SUBJECT: WATTS BAR NUCLEAR PLANT, UNIT 1 — SUMMARY OF CONFERENCE  
CALLS WITH TENNESSEE VALLEY AUTHORITY REGARDING THE CYCLE 6  
REFUELING OUTAGE STEAM GENERATOR TUBE INSPECTIONS (TAC NO.  
MC5629)

SUMMARY OF CONFERENCE CALLS  
TENNESSEE VALLEY AUTHORITY  
STEAM GENERATOR TUBE INSPECTION RESULTS  
FOR THE CYCLE 6 REFUELING OUTAGE  
WATTS BAR NUCLEAR PLANT, UNIT 1

March 9, 2005, Conference Call

#### March 15, 2005, Conference Call

- OD stress corrosion cracking axial indication dings in the cold leg:

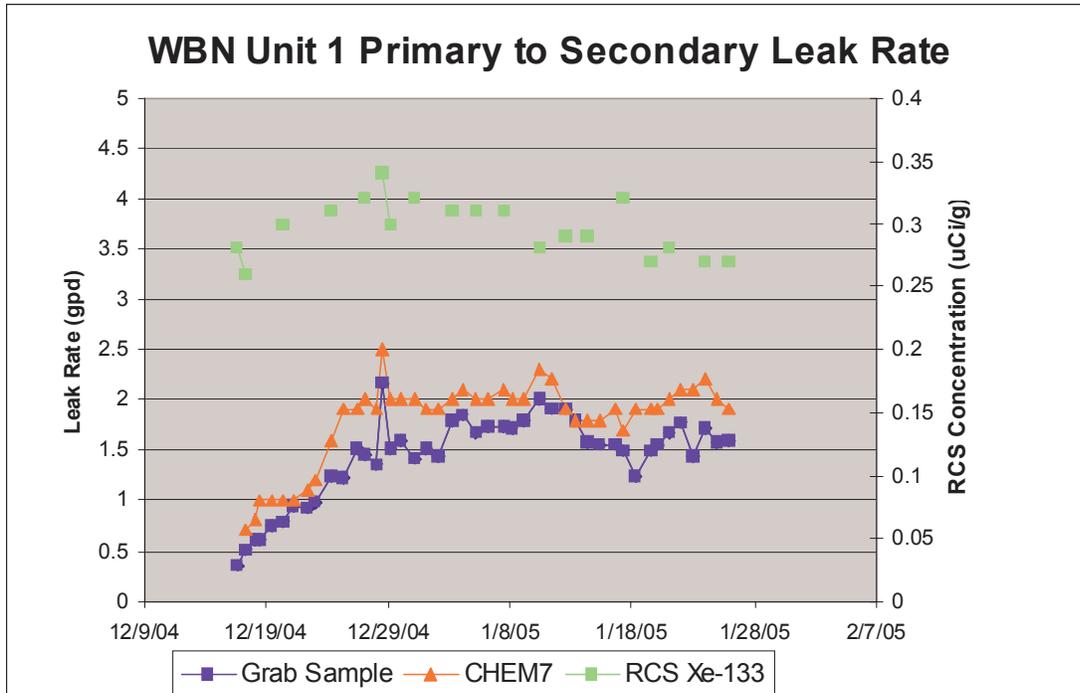
The initial scope of the inspection was a 20 percent sample of preheater dings above support plate CL 3. Based on the finding of an indication, the program was expanded to include 100 percent of pre-heater dings up to support plate CL 11. This expansion was based upon the experience at South Texas Project for detecting cracks in dings before these spread to higher regions in the SG. One additional crack in a ding was detected in support plate CL 3. These indications were not in situ tested since these were small indications and did not meet any screening criteria.
